TOWN OF BRISTOL, RHODE ISLAND

ZONING BOARD OF REVIEW

3A. 2025-41 Joseph M. Pardini - Special Use Permit: to construct a 32ft. x 44ft. three-story single-family dwelling with a height greater than 25 feet above grade within the flood zone. Located at 3 Slocum Street; Assessor's Plat 121, Lots 161 & 182; Zone: R-10

As this application is for a special use permit, it requires review by the Planning Board or its Technical Review Committee (TRC) per Section 28-409(b) of the Zoning Ordinance. The TRC held a meeting on November 20, 2025 to review this application. The TRC voted to recommend approval of the requested special use permit pending specific house design revisions (see attached memorandum from Diane Williamson).

E1: ELEVATION
3/16"=1'-0"

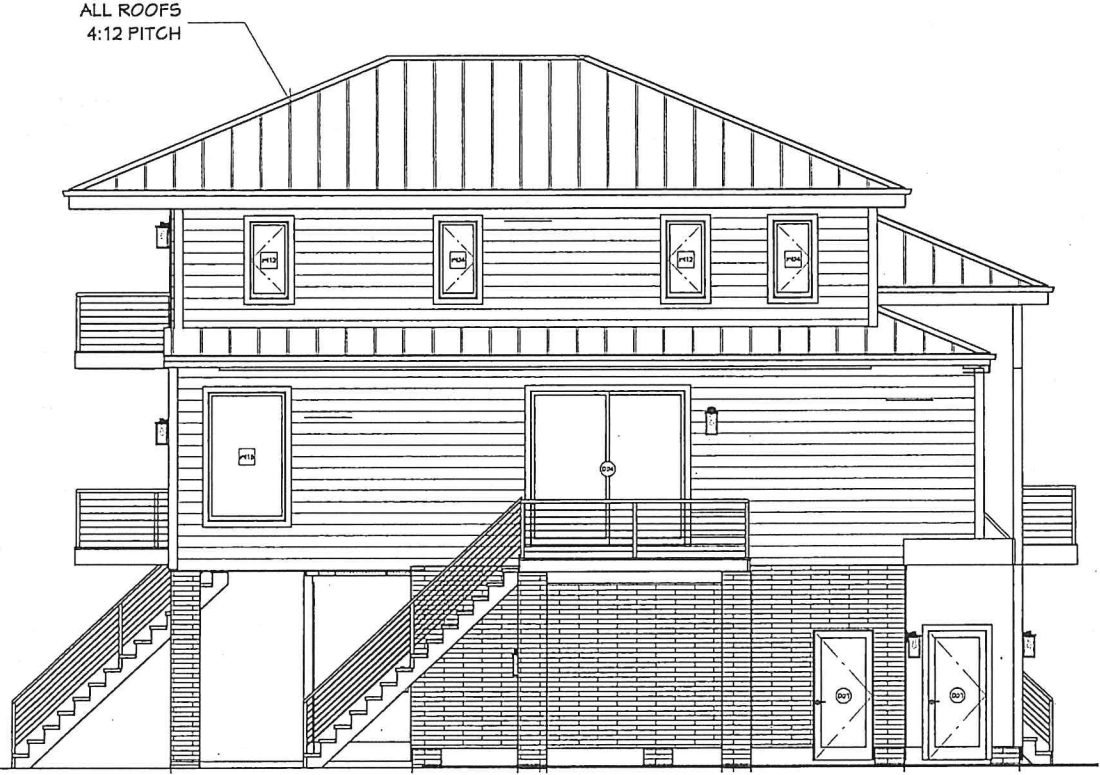
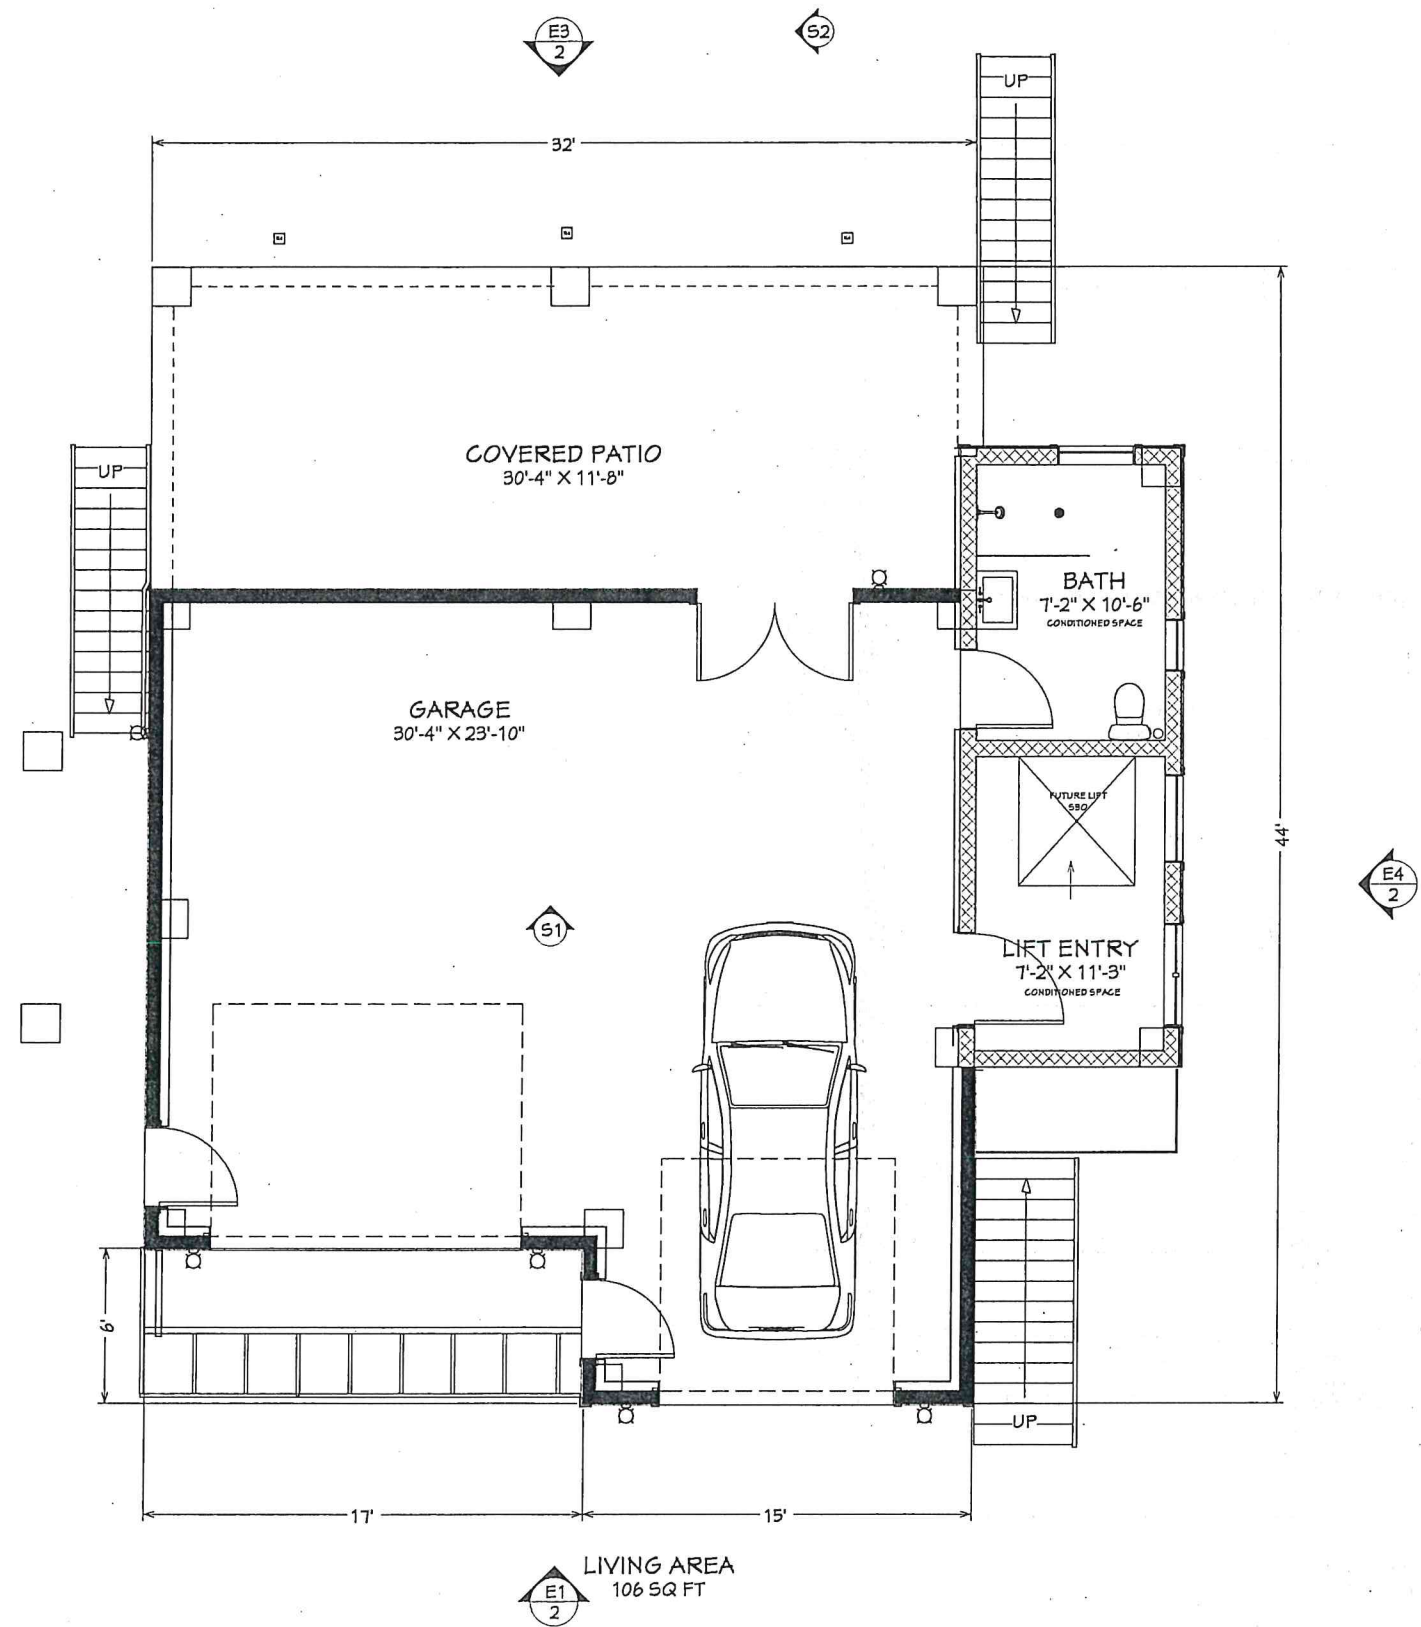
As noted previously, the TRC held a meeting on November 20, 2025 to review this application. At that meeting it was noted that the ordinance requires a roof pitch of at least 4/12. In addition, the TRC noted that the upper floor foot print should not exceed $\frac{2}{3}$ of the lower floor footprint. Deviations from these standards would require a dimensional variance(s). At the TRC meeting, the applicant noted that they would review the proposed design and work to meet the required special use permit standards; and revised plans will be submitted prior to the zoning board meeting.

- 1- The roof pitch is required to be 4:12 minimum (per Special Use Standards- Item #2
- 2- The second floor square footage is required to be 2/3 of the first floor square footage (per Special Use Standards- Item #4a)

- 1- Please see that the roofs are all now 4:12 pitch
- 2- The net square footage for the second floor is now less than 2/3 of the first floor.
See calculations below.

SECOND FLOOR PLAN
1/4"=1'-0"

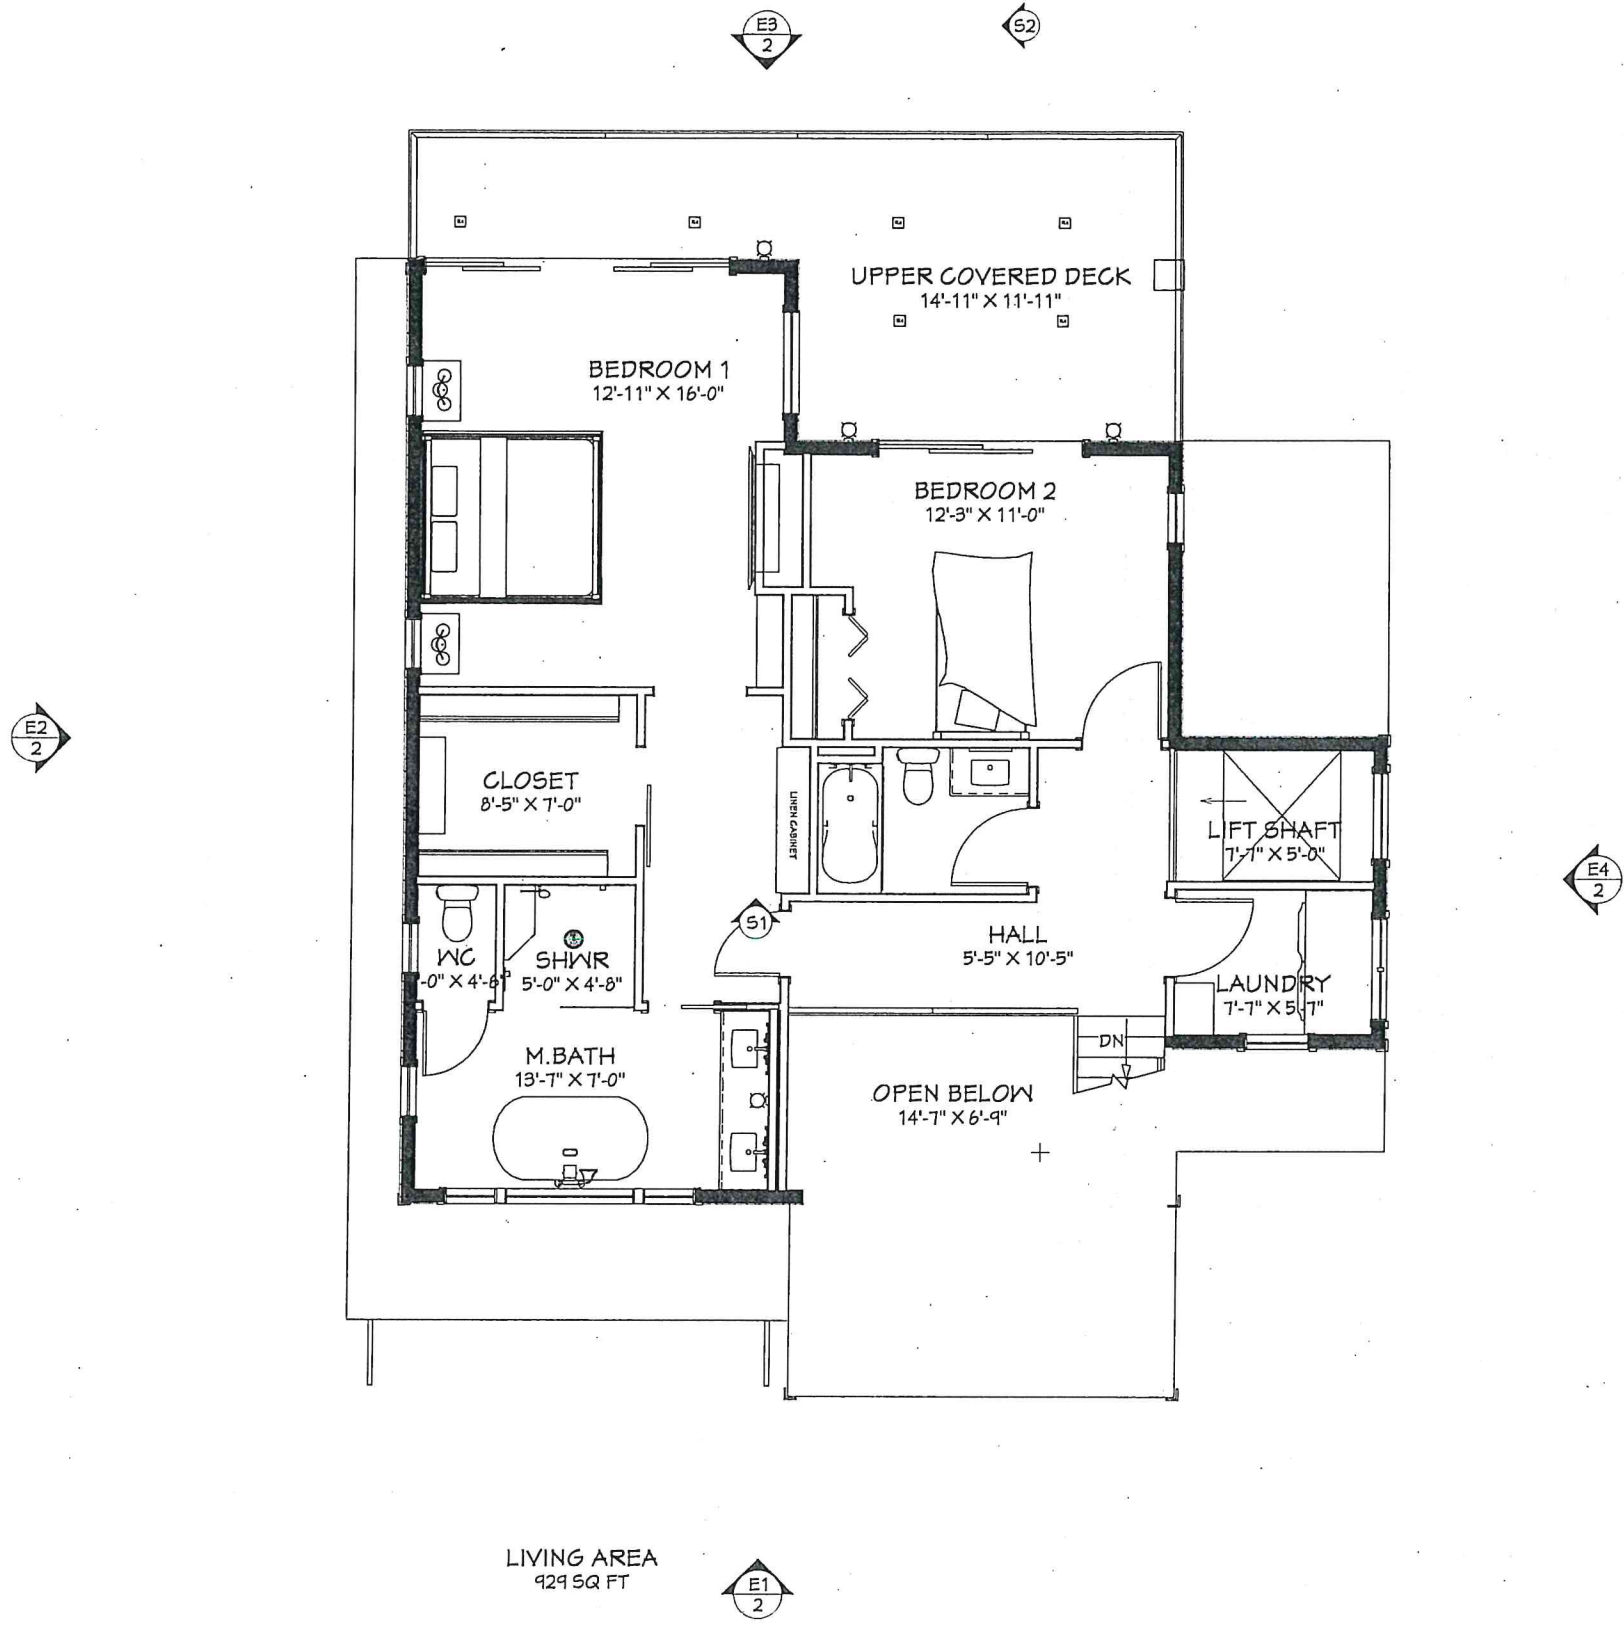
After review of the application materials, and discussions with the applicant's representatives, a motion was unanimously passed to recommend approval of the Special Use Permit subject to plan revisions for compliance with the standards of Section 28-150 (eee). Specifically, the TRC determined that the proposed design did not meet standard (2) requiring a roof pitch of no less than 4/12 and standard (4) requiring that the footprint of the second floor of living space not exceed 2/3 of the first floor footprint.

2nd floor: 929 SF

***2/3 of 1420 SF is 946.67 SF - Meets or exceeds the minimum requirement*
